Docket No. 50-336 B15476

Millstone Nuclear Power Station, Unit No. 2

Proposed Revision to Technical Specifications Reactor Protective and Engineered Safety Feature Actuation System Instrumentation

Marked-up Pages

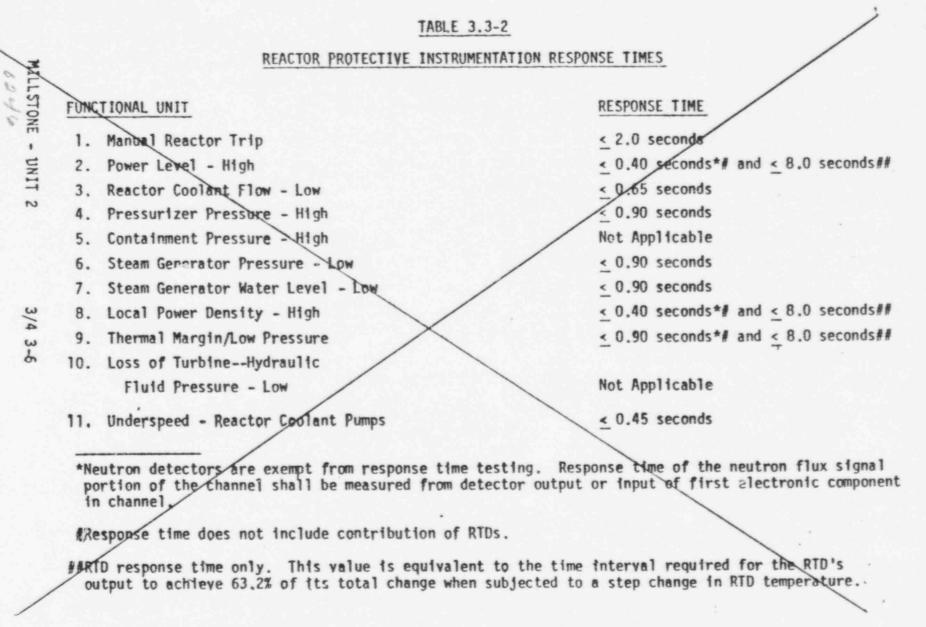
4.3.1.1.3 The REACTOR TRIP SYSTEM RESPONSE TIME of each reactor trip function shall be demonstrated to be within its limit at least once per 18 months. A Each test shall include at least one channel per function such that all channels are tested at least once every N times 18 months where N is the total number of redundant channels in a specific reactor trip function as shown in the "Total No. of Channels" column of Table 3.3-1.

4.3.1.1.4 The response time of all REACTOR TRIP SYSTEM resistance temperature detectors (RTD) shall be verified to be less than or equal to the value specified in Table 3.3-2 within one month of operation for newly installed RTD's and once every 18 months thereafter.

75 7 TANK + NEUTRON detectors are exempt from response time testing.

4.3.1.1.3 The REACTOR TRIP SYSTEM RESPONSE TIME of each reactor trip function shall be demonstrated to be within its limit at least once per 18 months. Neutron detectors are exempt from response time testing. Each test shall include at least one channel per function such that all channels are tested at least once every N times 18 months where N is the total number of redundant channels in a specific reactor trip function as shown in the "Total No. of Channels" column of Table 3.3-1.

TABLE 3.3-4 (Continued)

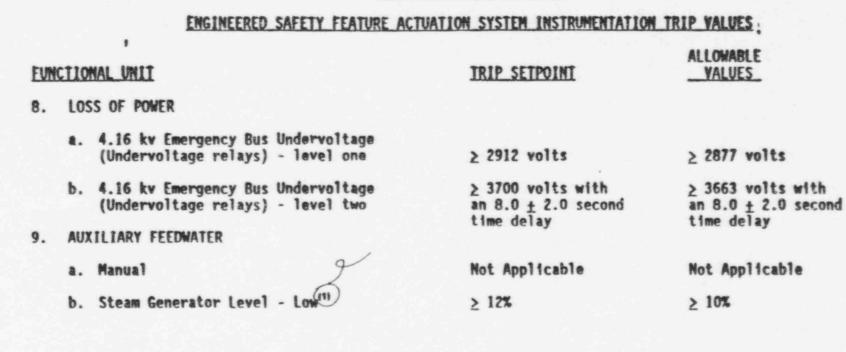
(1) For Cycle 12 only, OPERABILITY of the auxiliary feedwater (AFW) automatic initiation logic will rely on operator action to ensure successful initiation of AFW. Prior to startup for Cycle 13, modifications to the automatic initiation logic for AFW will be implemented to eliminate the reliance on operator action. -36-94 6/7/94

(1) For Cycle 12 only, OPERABILITY of the auxiliary feedwater (AFW) automatic initiation logic will rely on operator action to ensure successful initiation of AFW. Prior to startup for Cycle 13, modifications to the automatic initiation logic for AFW will be implemented to eliminate the reliance on operator action. 6/7/94
